# LAREDO COLLEGE VETERANS SERVICES CENTER ADDENDUM No. 2

DATED: December 05, 2024

- **PROJECT:** Veterans services center Sheridan Rd, Laredo, TX 78040
- ARCHITECT: Cavazos Architects 9114 McPherson Rd. #2501 Laredo, Texas 78045 956/724-8123

## ADDENDUM #2

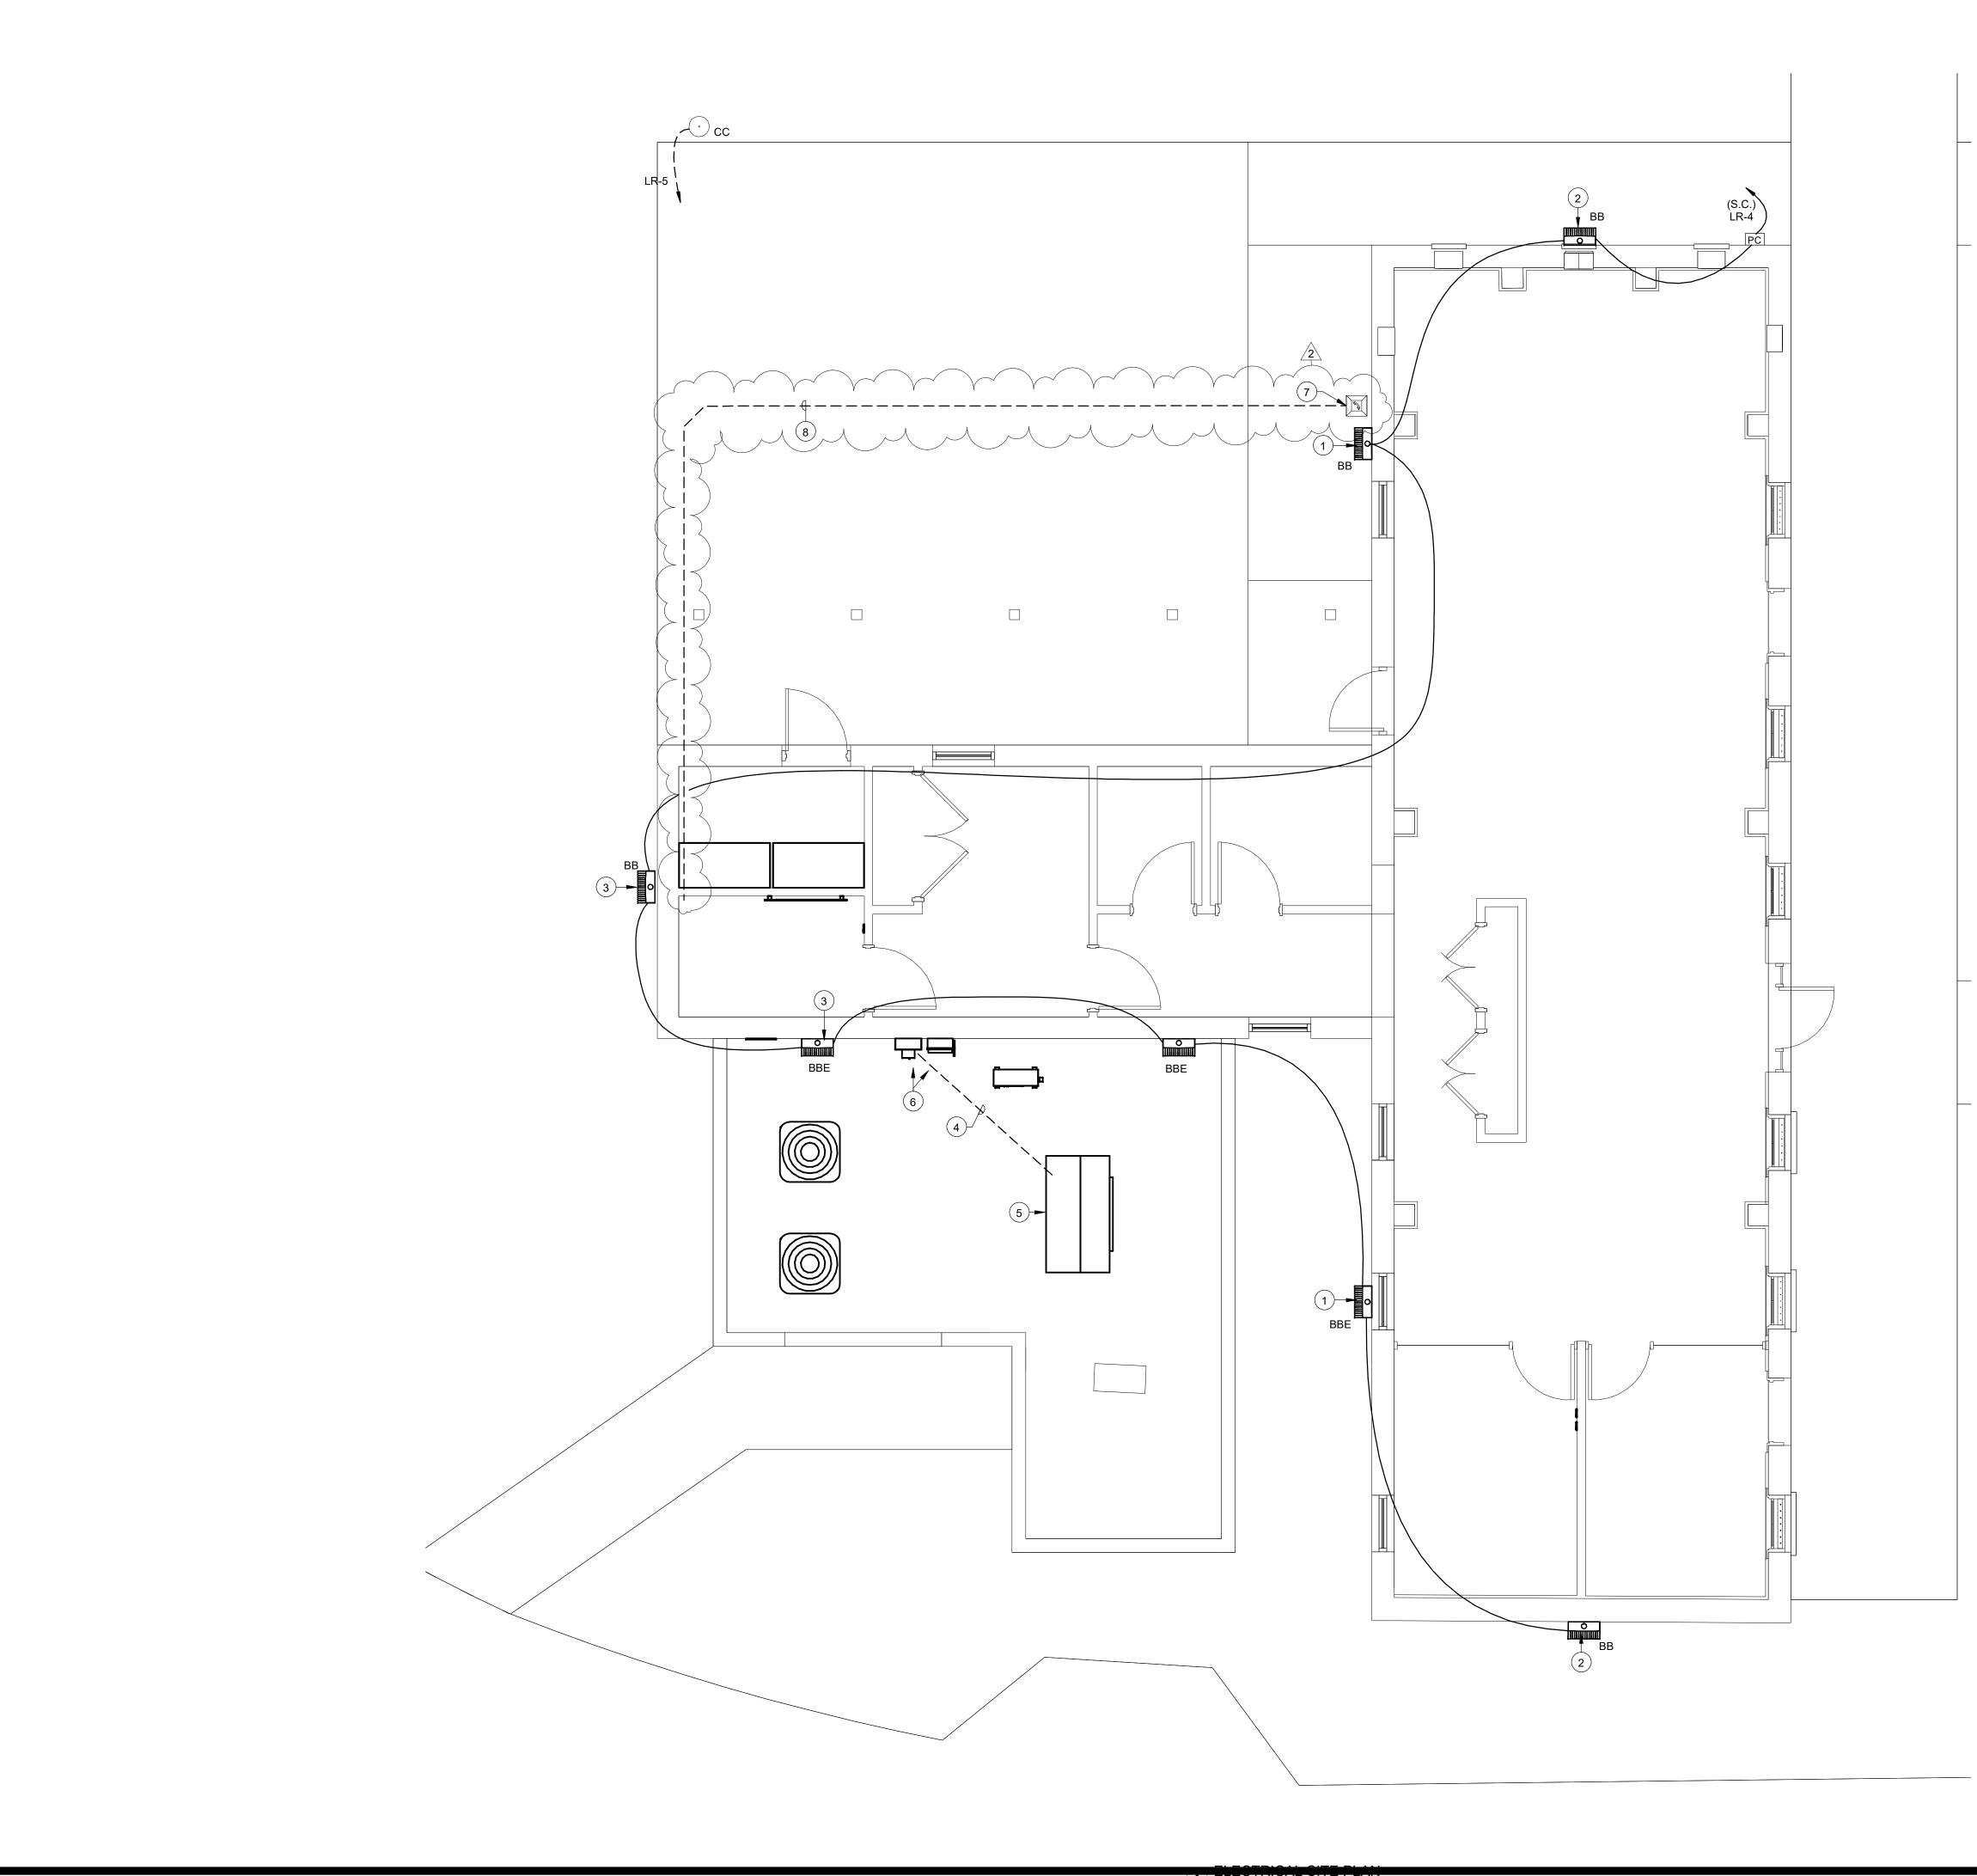
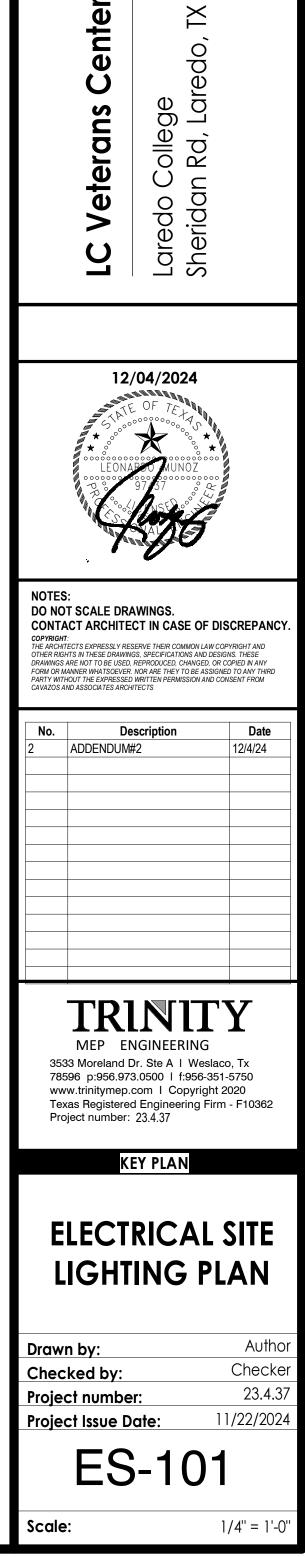
- I. Specifications: N/A
- II. General: N/A
- III. Mechanical:
- IV. Electrical:
  - A. Sheet EDP-101 Existing telephone pedestal shall be relocated by contractor, refer to attachment.
  - B. Sheet ES-101 Existing telephone pedestal proposed new location with new conduit to MDF room, refer to attachment.
- I. Plumbing: N/A
- II. Fire Protection: N/A

#### Page T001 TECHNOLOGY SITE PLAN

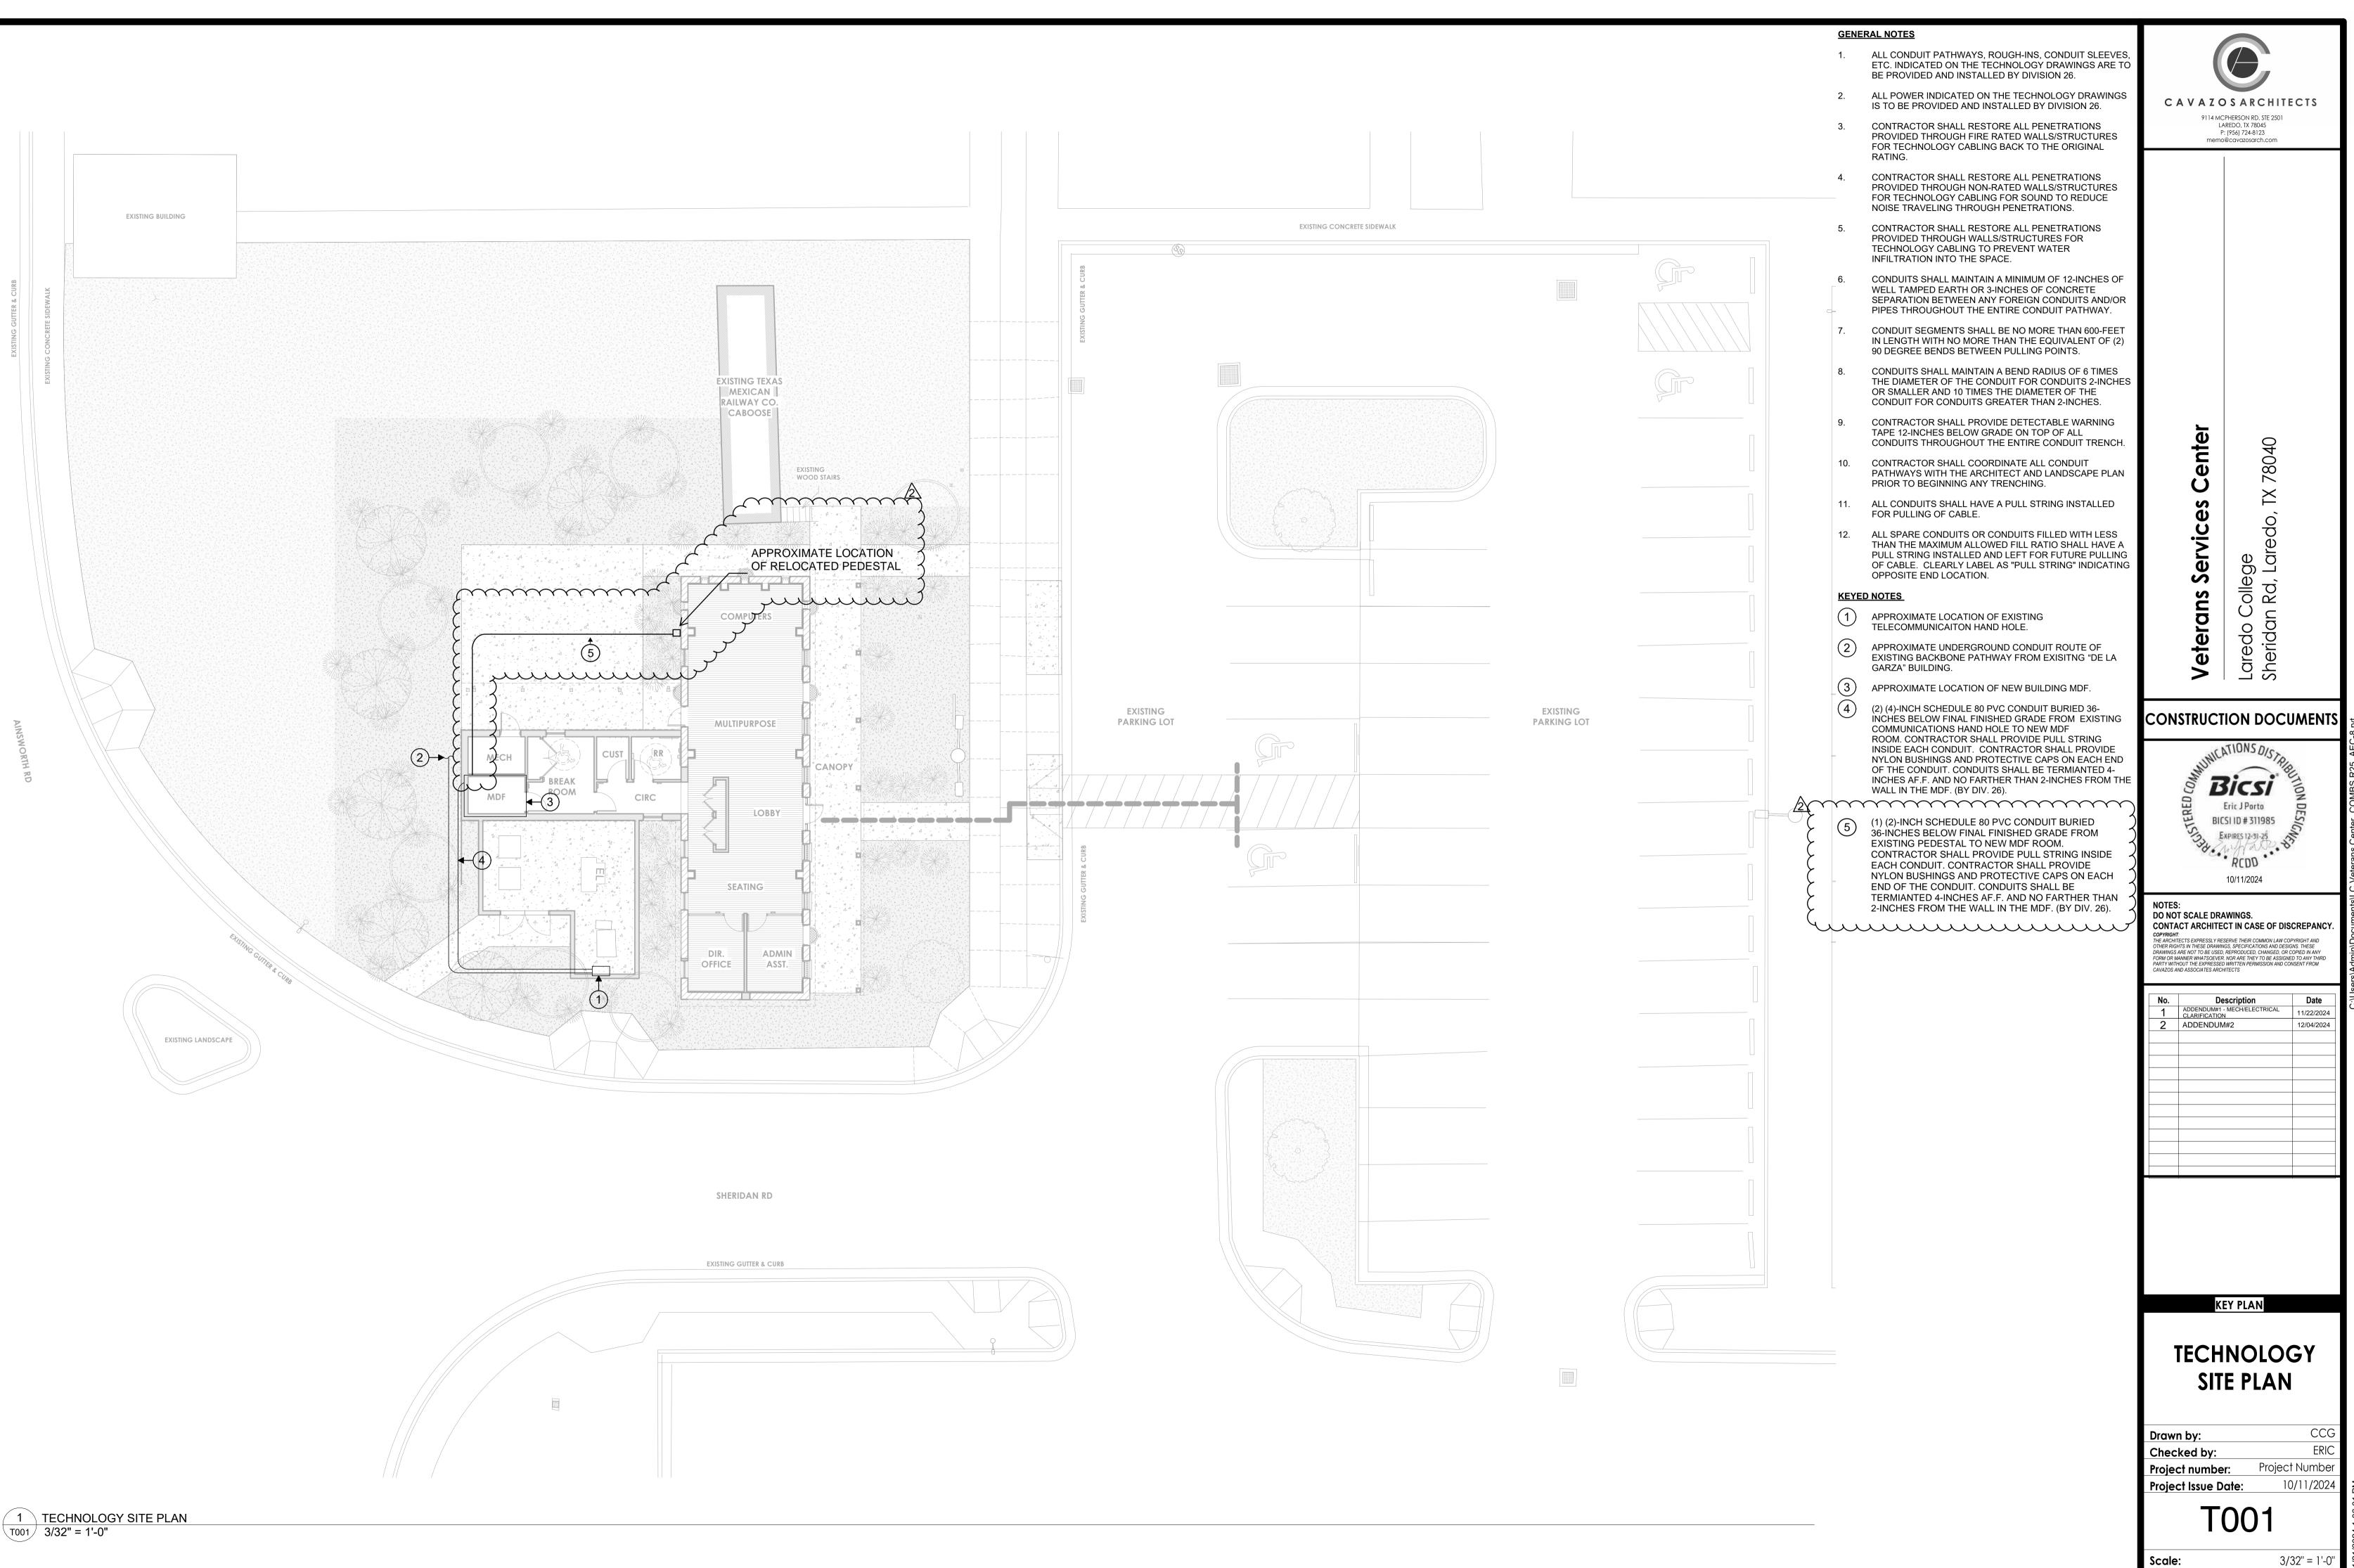
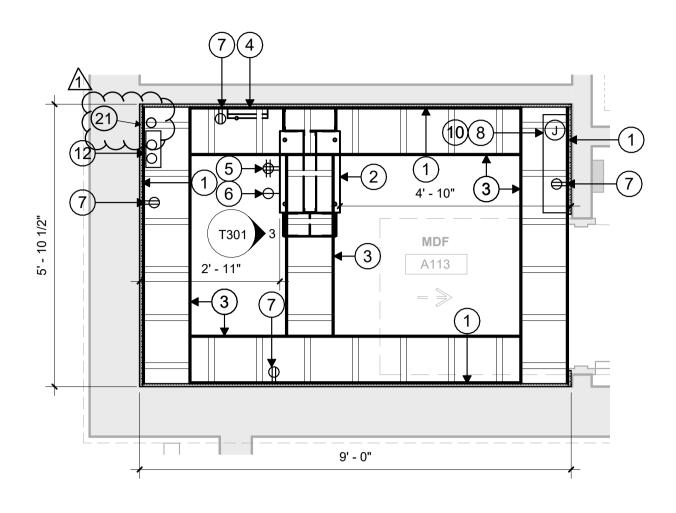
- ADDED (1) 2-inch conduit from the MDF to the relocated pedestal.

# TECHNOLOGY ENLARGED VIEWS

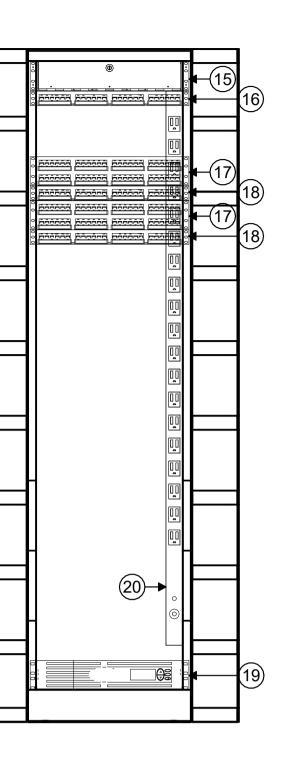
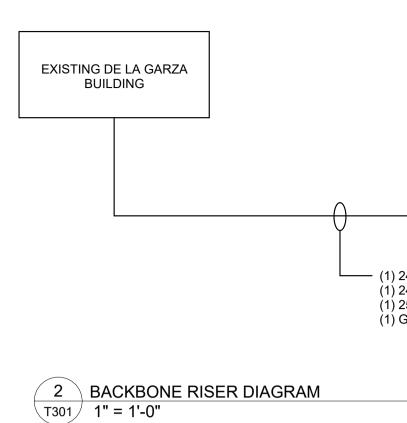
- ADDED (1) 2-inch conduit location from the MDF to the relocated pedestal.
